## Certified Action of the City of Raleigh Planning Commission

**Case File / Name:** SP- 43-09 / Lot 5 Cheviot Assemblage

**Nature of Case:** This request is to approve a 28,372 square foot two story auto dealership on a 4.97 acre site, zoned Industrial-1. The building will consist of 9,364 square feet sales component 1<sup>st</sup> floor with 39 parking spaces and approximately 15,817 square feet of service area (18 service bays) and storage 1<sup>st</sup> floor with 54 parking spaces and 3,191 square feet of storage 2<sup>nd</sup> floor. 247 parking spaces are provided for vehicle display/show room and inventory storage for a total of 340 parking spaces for the entire site. This site is located within 400 feet of a residential use or zone.

SP- 43- 09 Lot 5 Cheviot Assemblage – site map

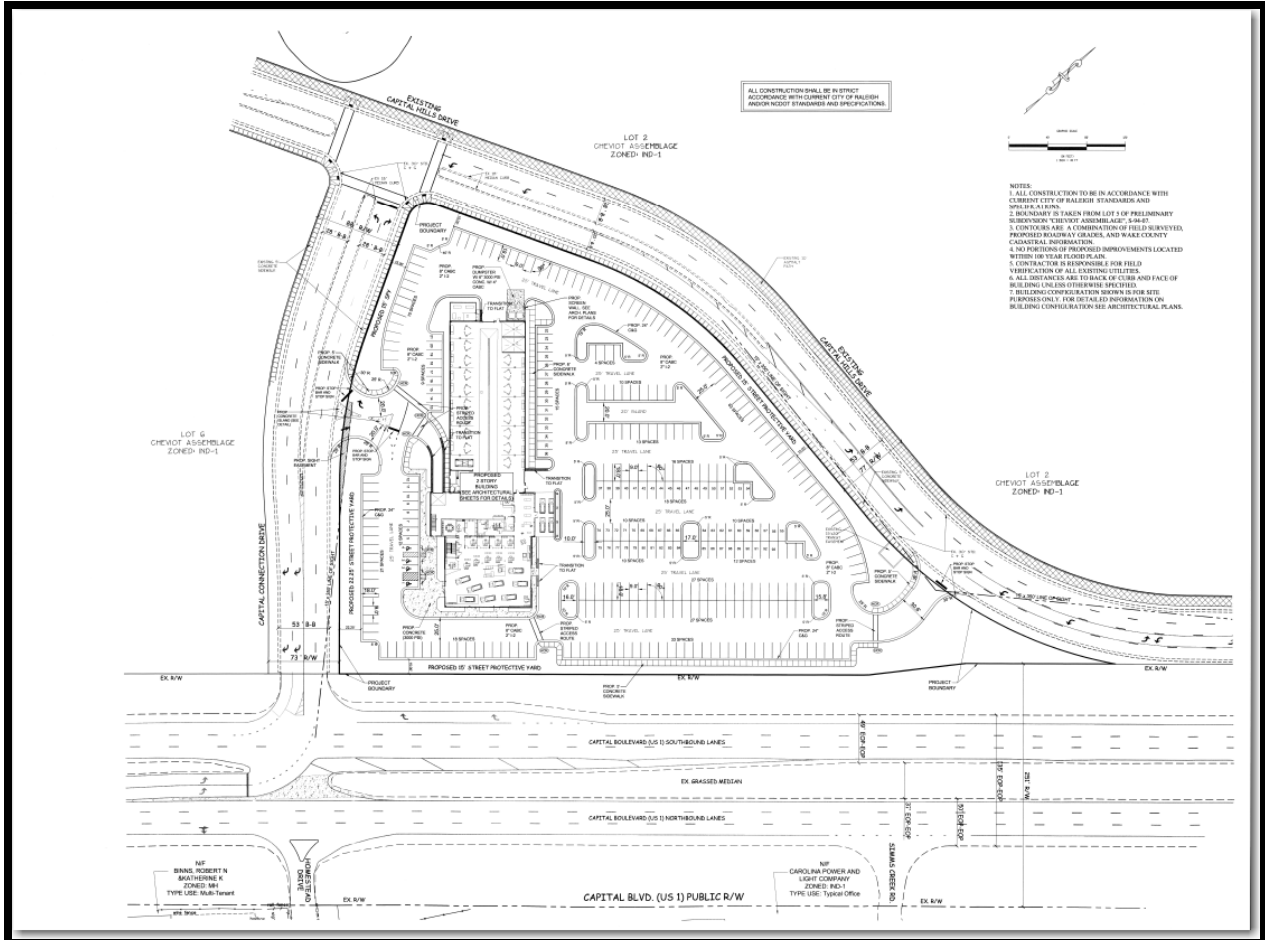
<b>Comment</b>	<b>Response</b>
<p>1. The committee recommends that, mindful of both present and potential site uses and points of roadway access, pedestrian connectivity be increased to and across the site, to provide:</p> <ul style="list-style-type: none"> <li>• A direct, continuous sidewalk from the driveway on Capital Hills Drive, across the property's Capitol Boulevard frontage, to Capital Connection Drive.</li> <li>• Direct access, via sidewalk, striped crosswalk(s) and median, across Capital Connections Drive to Lot 6.</li> <li>• Direct access via striped crosswalk across Capital Hills</li> </ul>	<p>The developer chooses not to add additional sidewalk along Capital Blvd for the following reasons:</p> <ul style="list-style-type: none"> <li>• The use of this site plan is a very low generator of/destination for pedestrian traffic. At such time that the parcel might redevelop with a use that would be more dependent upon pedestrian traffic, a site plan for the change in use would be required by the City and the need/appropriateness</li> </ul>

Drive. If roadway design precludes providing a crosswalk at that point, the committee suggests that the 15'x20' transit easement be moved to a less isolated location (i.e., closer to proposed or anticipated buildings).

2. Install a means of dimming pole-mounted lights after regular business hours, to reduce reflective uplight and glare.

for additional walks could be more effectively handled at that time.

- A striped pedestrian crossing with pedestrian refuge via dividing median is currently provided across Capital Connection Drive at the intersection of Capital Hills Drive and Capital Connection Drive which will probably be a signalized intersection in the future. The configuration of the currently proposed crosswalk is conducive to a safe and functional pedestrian crossing. A striped crosswalk in the vicinity of the intersection of Capital Connection Drive and Capital Blvd would have no median point of refuge and would probably be much less safe in function than the currently proposed crossing. Additionally, the currently proposed crossing is at a location that provides convenient access/circulation between not only Lots 5 & 6 (across Capital Connection Drive), but also a short and convenient connection between the sidewalk system on the east side of Capital Hills Drive with the greenway system/multipurpose trail on the west side of the road. The developer chooses not to add an additional crosswalk and sidewalks along Capital Blvd.

- The developer is agreeable to adding a striped crosswalk in this location if

the City DOT concurs that such a crosswalk will not pose a safety problem for pedestrians or an impediment to the traffic carrying function of Capital Hills Drive.

2. The plan meets all City standards as to light levels. The developer chooses not to revise the plans.
